Notice of Allowability	Application No.	Applicant(s)	
	10/800,275	SOMERS ET AL.	
	Examiner	Art Unit	
	William H. Mayo III	2831

DETAILED ACTION

FIG. 2

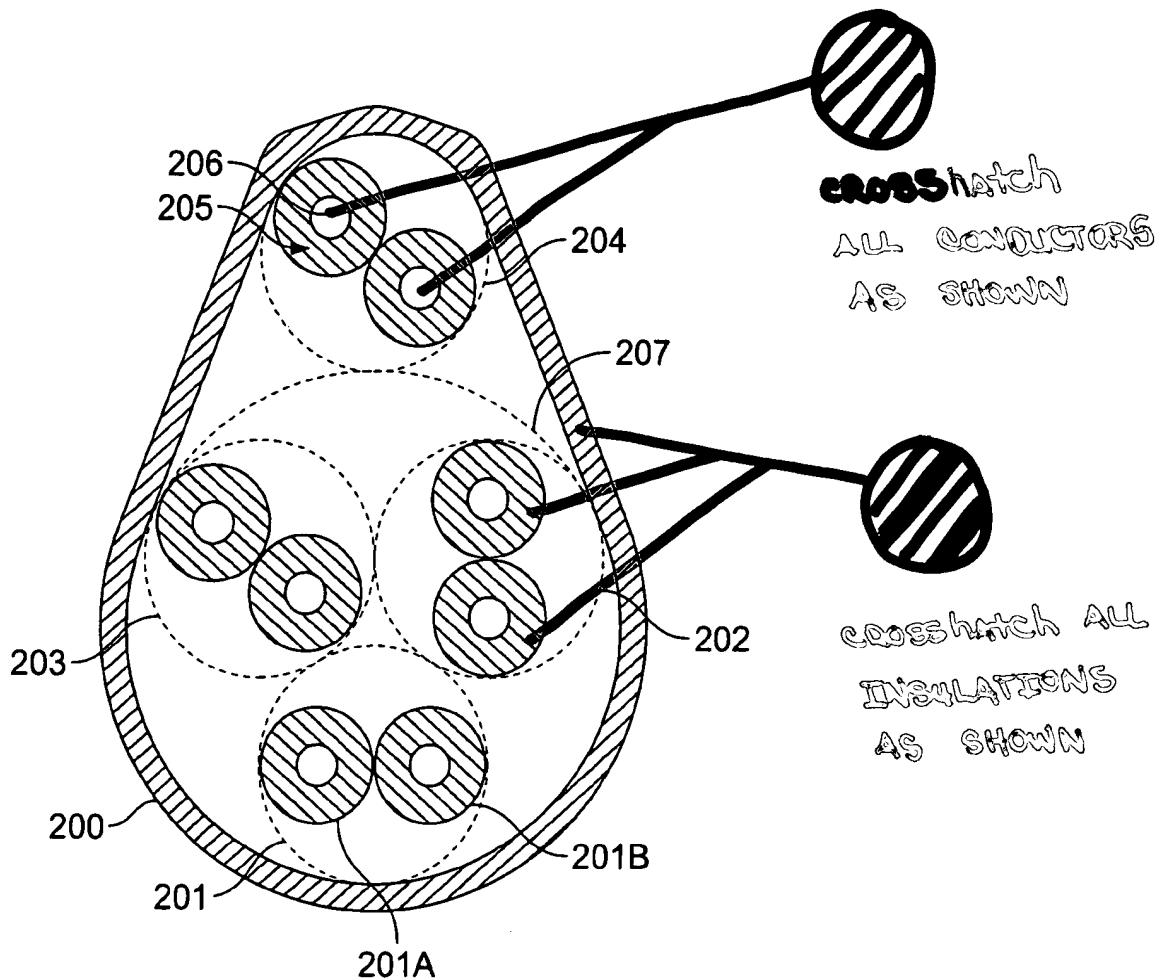
1. The following changes to the drawings have been approved by the examiner and agreed upon by applicant: Please refer to the enclosed corrected drawings sheet for the reference when submitting new drawings. In order to avoid abandonment of the application, applicant must make these above agreed upon drawing changes.
2. In addition to Replacement Sheets containing the corrected drawing figure(s), applicant is required to submit a marked-up copy of each Replacement Sheet including annotations indicating the changes made to the previous version. The marked-up copy must be clearly labeled as "Annotated Sheets" and must be presented in the amendment or remarks section that explains the change(s) to the drawings. See 37 CFR 1.121(d)(1). Failure to timely submit the proposed drawing and marked-up copy will result in the abandonment of the application.
